**RE: SITE PLAN FOR HAMLING PROPERTY
SECTION 16, BLOCK 3, LOT 14
12 SILVERTAIL ROAD
TOWN OF CHESTER
W.O. #1884.01**

In response to your review comments on the Planning Board application for the Hamling Property, we performed a soil percolation test on November 9, 2022. The test was performed within the approved absorption field area shown on Lot 16 on the filed maps for the Hambletonian Hills subdivision. The test was done at a depth of 24 inches, and was witnessed by your office.

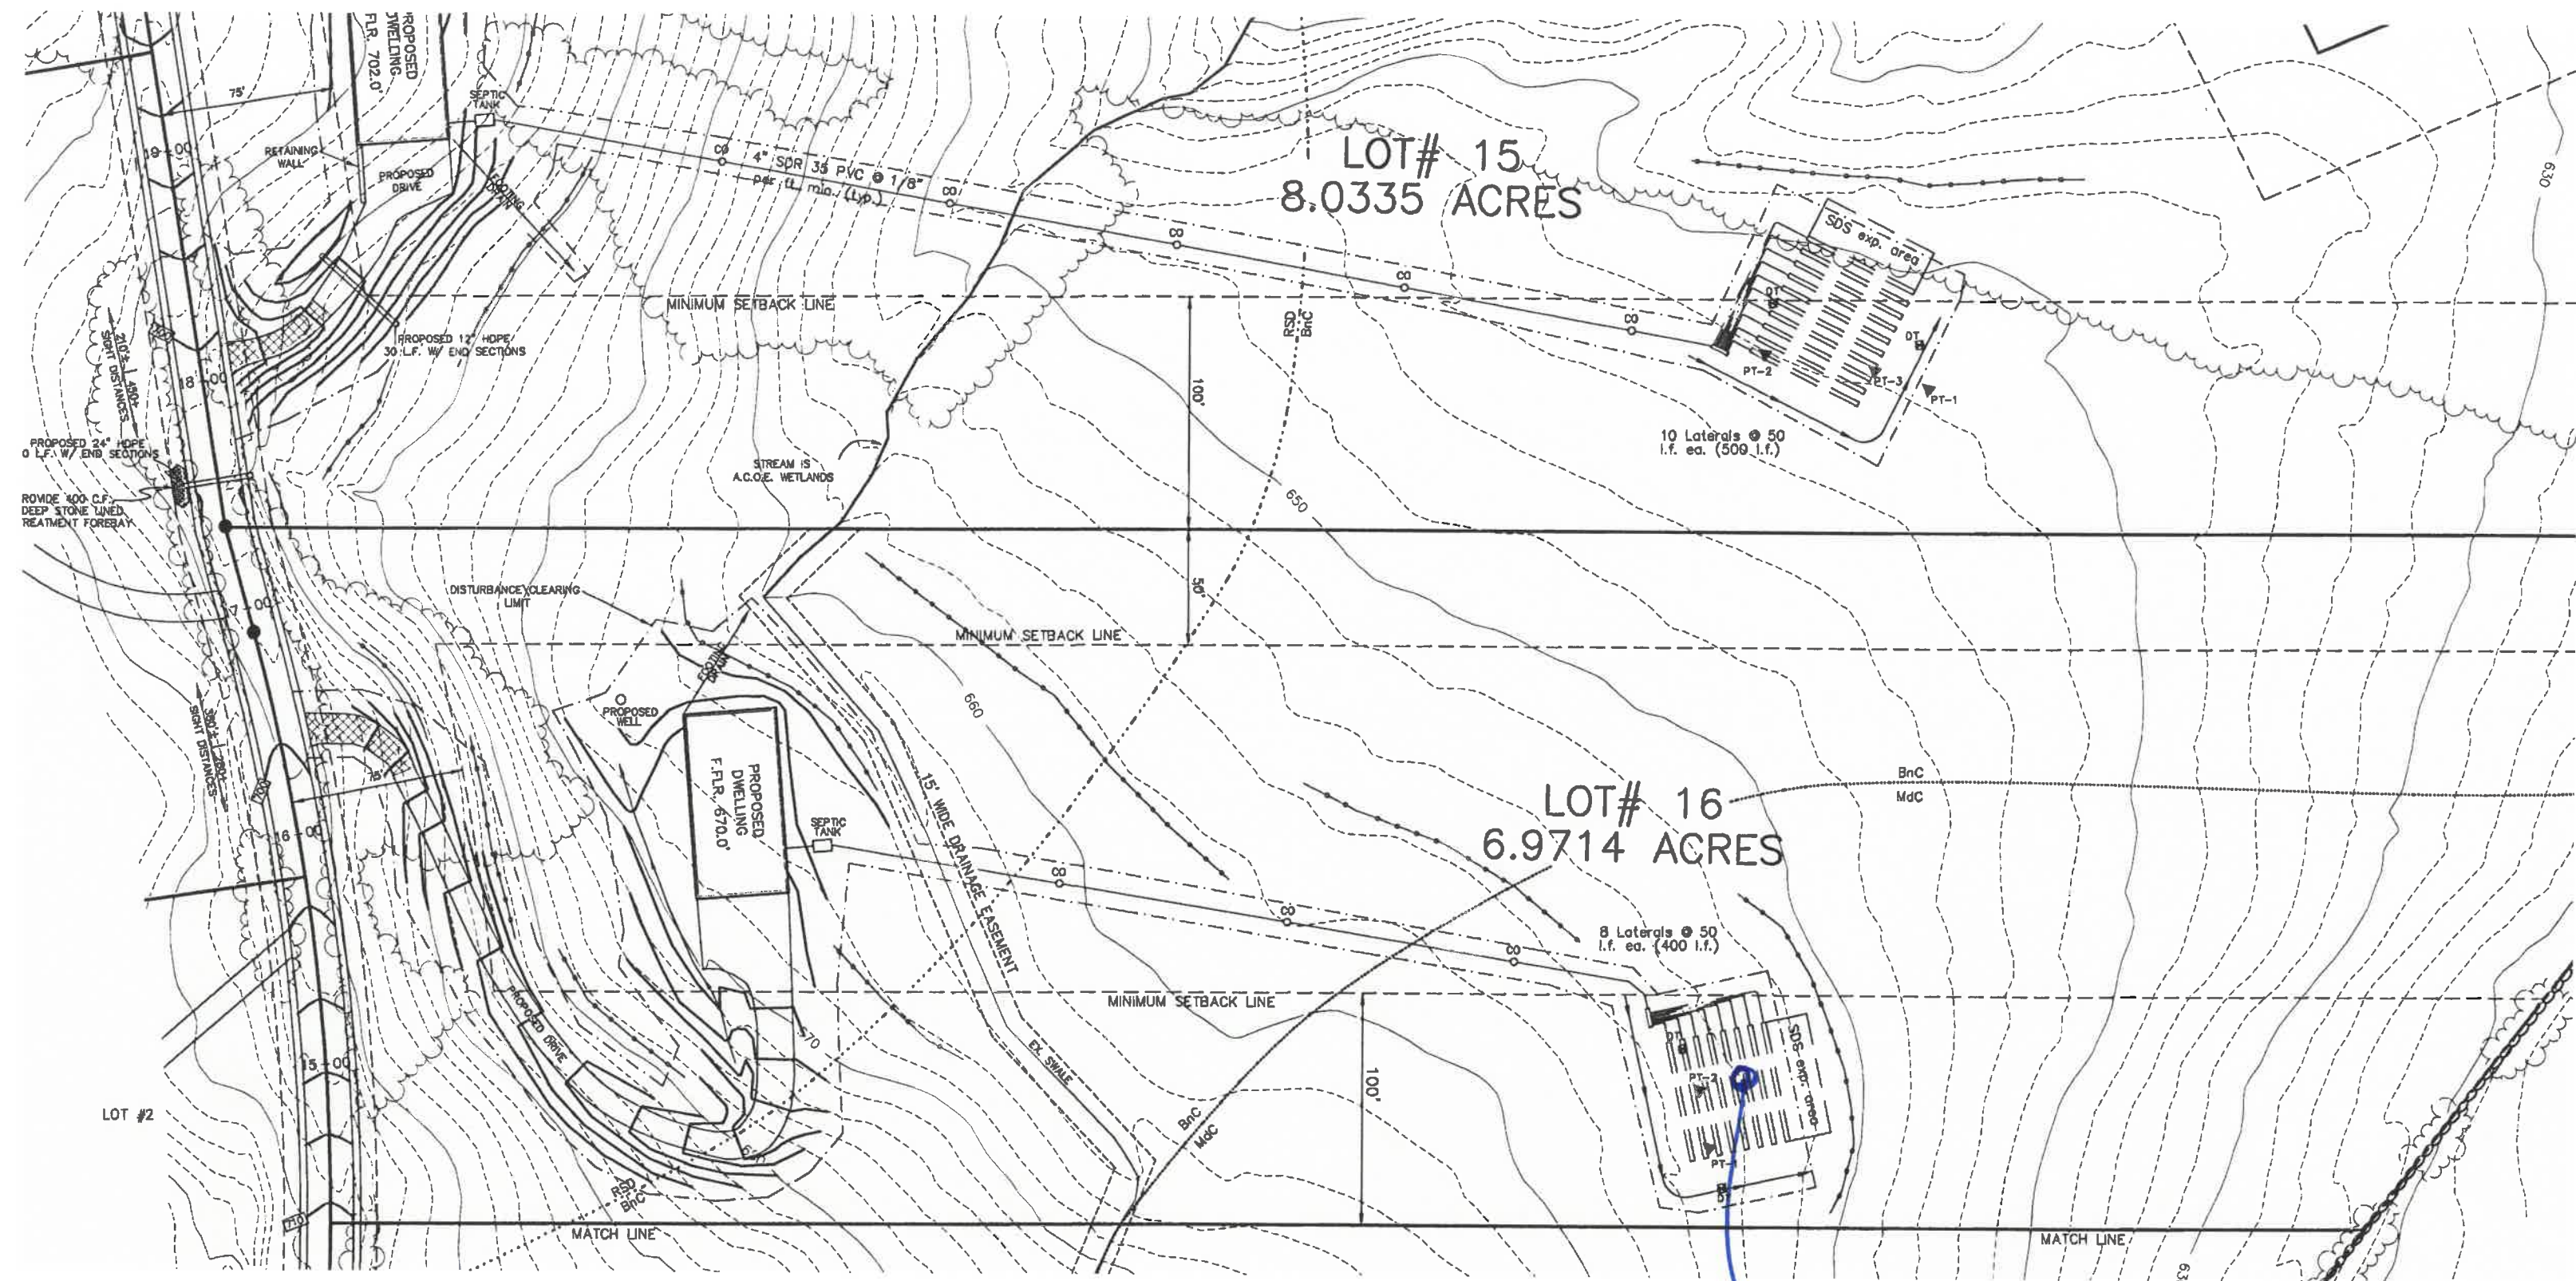
As shown on the enclosed Sewage Disposal System Installation Requirements Table from the filed maps, the system for Lot 16 was designed for a percolation rate of 16 to 20 minutes per inch. During our test yesterday, we measured a stabilized percolation rate of 20.5 minutes per inch, which falls under the 21-to-30 mpi class in the NYS Design Handbook.

The filed maps specify that a field length of 400 lineal feet must be installed for a 4-bedroom home. Based on the new rate of 20.5 minutes per inch and the current NYS design standard of 110 gallons per day per bedroom, the required field length for a four-bedroom home is 367 feet. Therefore, we conclude that the approved design that specifies 400 lineal feet is still applicable for the Hamling project.
